# City of Jackson

RE: Fire Station No. 1 Renovation Project- Change Order No. 3:  
COR 008- Lintels for Windows in Existing Walls (RFI 22)  
COR 009- EMS Storage Room 140 Shoring Ceiling and Enclosure Ceiling Opening (RFI 18)  
COR 003- P-3 Walls on South and East Walls of Training Room 001  
COR 011- Stair 1 Wall Height (RFI 20)  
COR 002- Lav Shields in Place of Lav Guards on P3 Fixtures  
COR 007- Shower Bases (RFI 17)  
COR 010- Floor Sink in Basement Mechanical Room (RFI 23)

# Change Order

Project: Jackson Fire Station #1  
Building Addition and Renovations

**Subject:**  
Window Header in Existing Walls

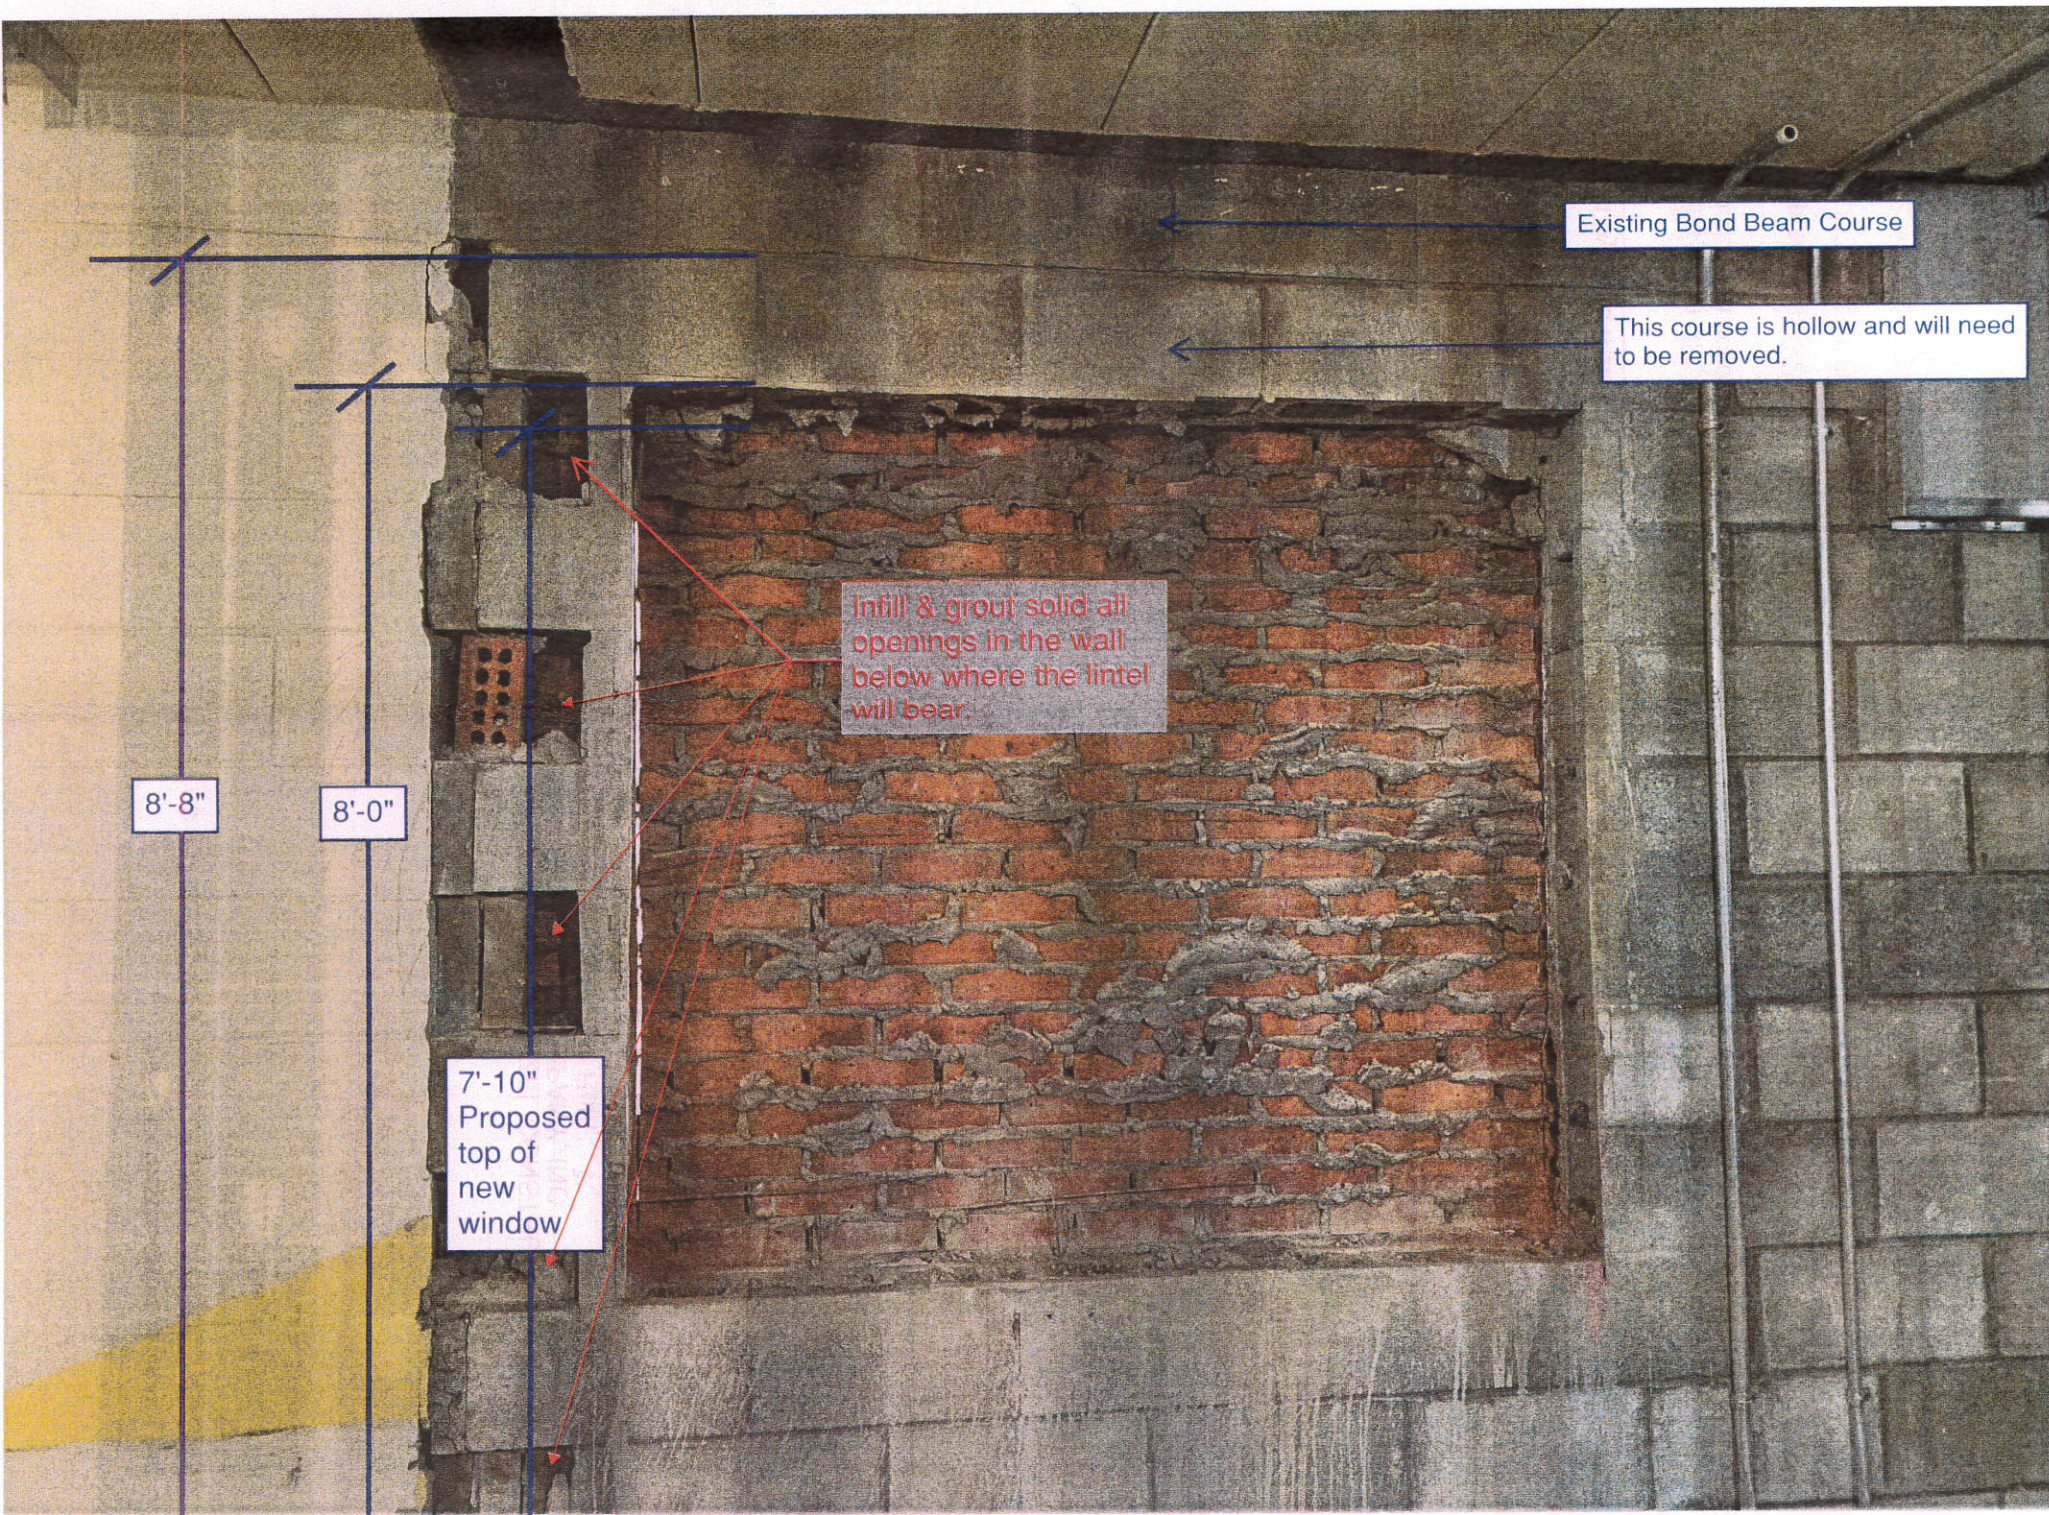
Please reference Window Head Detail (Existing Wall) 14/A3.4. This detail shows an existing CMU bond beam at the top of the new window. Drawing A2.1 shows the top of the windows to be at 7'-10" above the floor. While demoing the new openings, it was found that the existing CMU bond beam is roughly 8'-8" above the floor, which is 10" higher than the proposed top of window. Please see attached picture of a new opening onsite with added comments. There are no steel lintels called out on the drawings for these openings either. Please advise how this 10" gap between the bottom of the bond beam and the top of the window should be infilled.

Please note that the Pella windows have already been made and are sitting in the installer's warehouse.

For the steel lintels for the new window openings in the existing 6" CMU block walls of the office building use the following:

- (2) L 2 1/2 x 2 1/2 x 5/16 angles back to back (window width 5'-0" – window type C)
- (2) L 2 1/2 x 2 1/2 x 1/4 angles back to back (window width 3'-4" or smaller – window types A, B, & D)

The pair of steel lintels can be connected bolted @ 32" o.c. per the cover sheet instructions or welded (1" per 12" of angle) and the angles can be painted with galvanized paint.

Existing Bond Beam Course

This course is hollow and will need to be removed.

Infill & grout solid all openings in the wall below where the lintel will bear.

# **BASEMENT FLOOR PLAN**

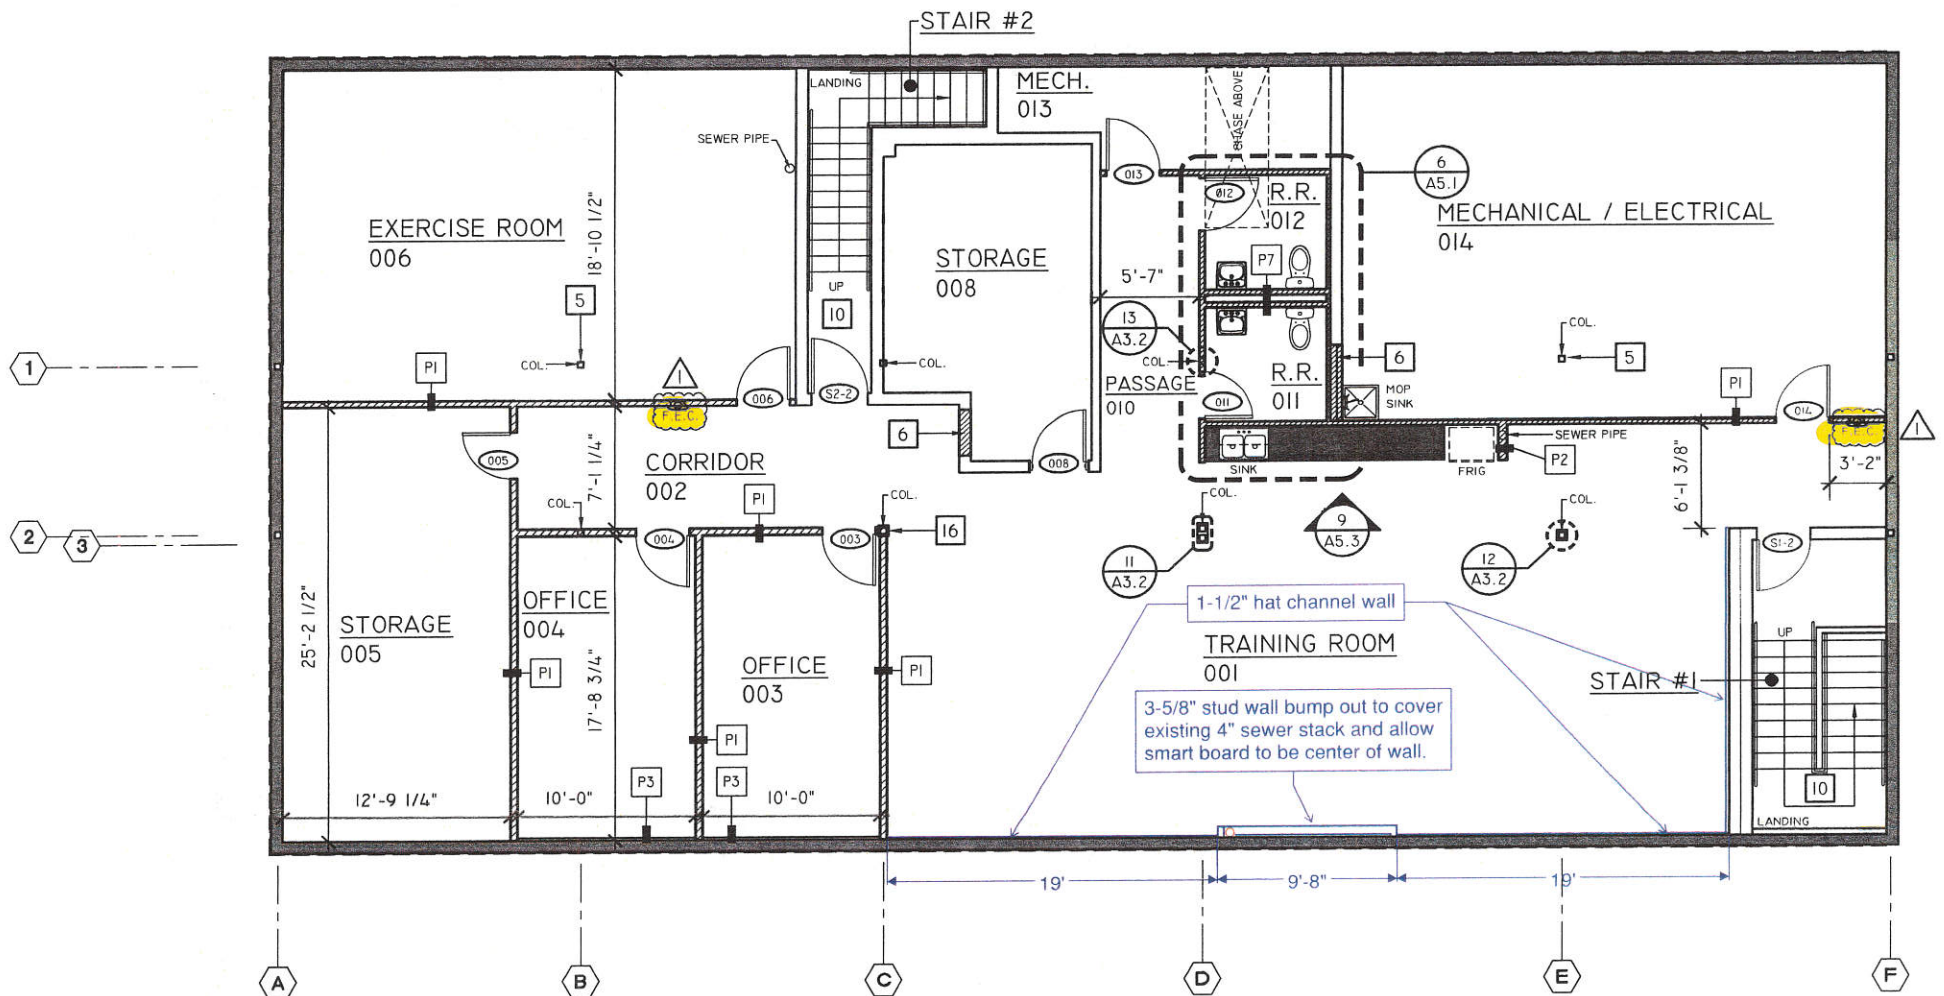
Floor plan drawing A1.1 does not call out for the South and East walls of Training Room 001 to be furred out with drywall, but the finish schedule on A4.1 calls out for these walls to be painted drywall. After a site visit it was determined there is also a 4" sewer stack that needs to be covered on the South wall. Penzel plans to install a 3-5/8" stud wall bump out to cover this sewer stack and allow the smart board to be installed in the center of the room. The remaining South and East walls of this room will be furred out with 1-1/2" hat channel. See attached sketch showing the proposed plan. Penzel requests to be compensated for this change in scope in the amount of \$3,261.72.

**LAV SHIELD®**  
LAVATORY PROTECTIVE ENCLOSURES

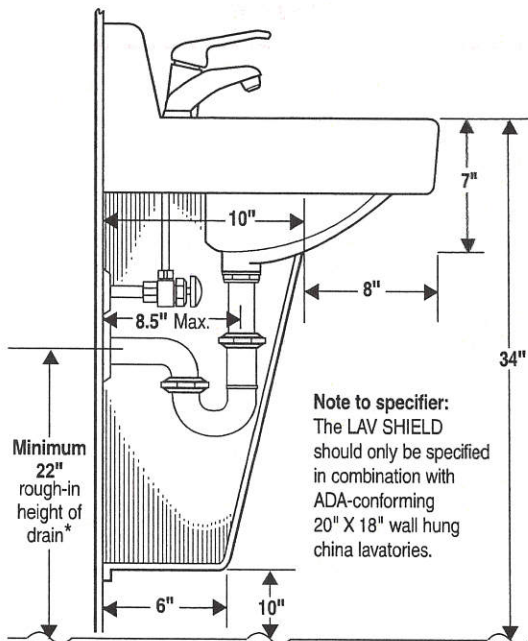
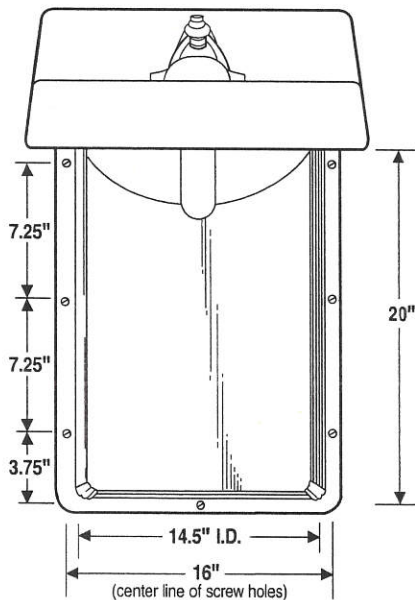
Provide Lav Shields for seven P3 fixtures in lieu of specified lav guards. Lav shield cut sheet attached.

Per response to the plumbing fixtures submittal review comments, Lav Shields are required to be used on the (7) EA - P3 fixtures in lieu of the specified Lav Guards. Penzel Construction Company requests to be compensated for this change in scope in the amount of \$1,715.70.
